Ashfield Commuter Car Park

Determination Report

Ashfield Commuter Car Park Determination Report

**Transport Access Program
Ref - 5652263**

Figure 2 Updated design of Ashfield Commuter Car Park (Subject to detailed design)

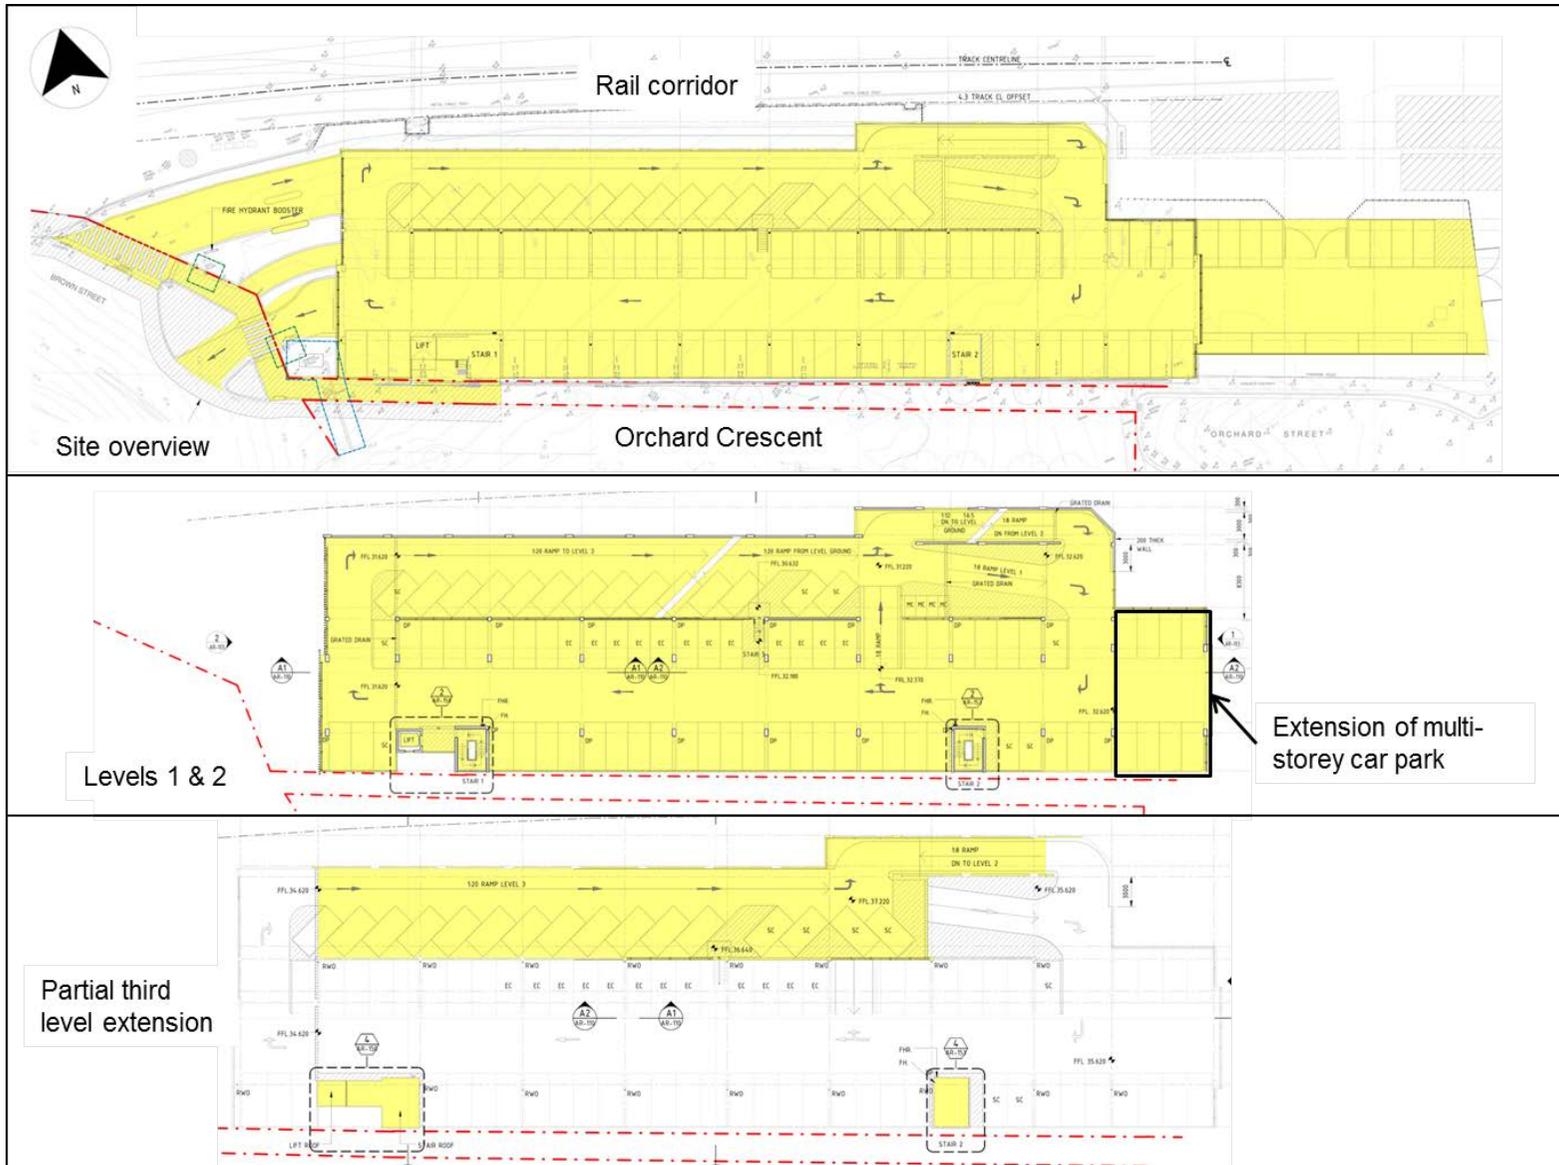
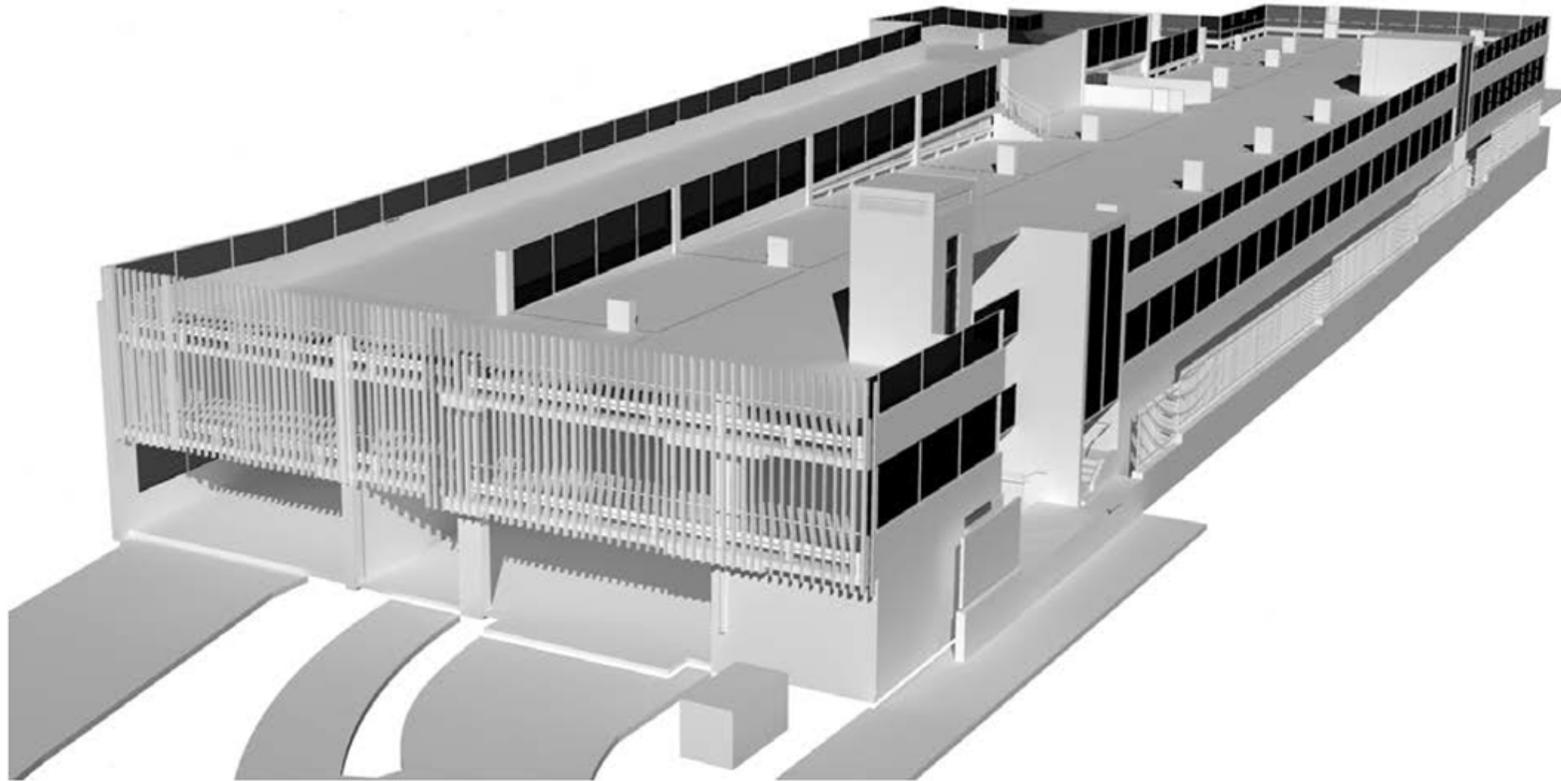
- an addition of a partial third level of parking added to the car park on the rail corridor side
- an extension of two levels of the multi-storey car park at the south of the site over the existing at-grade car park
- changes to the internal configuration of ramps, location of lift structures and circulation within the multi-storey car park
- a split entrance/exit onto Brown Street
- modifying the pedestrian pathway between the proposed multi-storey car park and Ashfield Station ensure DDA compliance.

| Item/aspect | Original design | Updated design |
|--|---|---|
| Motorcycle parking spaces | <p>No motorcycle spaces were incorporated into the original design.</p> | <p>Two submissions identified motorcycle parking spaces as a key area which was not focused on in the original REF.</p> <p>Due to the re-configured design, at least 10 motorcycle parking spaces are now able to be incorporated into the proposed multi-storey car park.</p> |
| DDA compliant pedestrian path between the multi-storey car park and Ashfield Station | <p>The original design did not incorporate any modifications to the pedestrian path between the Proposed Activity and Ashfield Station.</p> | <p>A number of community and Council submissions called for the upgrade of the pedestrian path between Ashfield Station and the Proposed Activity.</p> <p>The Proposed Activity now includes the modification of the pedestrian path between the entrance/exit of the Proposed Activity and Ashfield station to ensure DDA compliance.</p> |

Figure 2 and Figure 3 details the updated design of the multi-storey car park including:
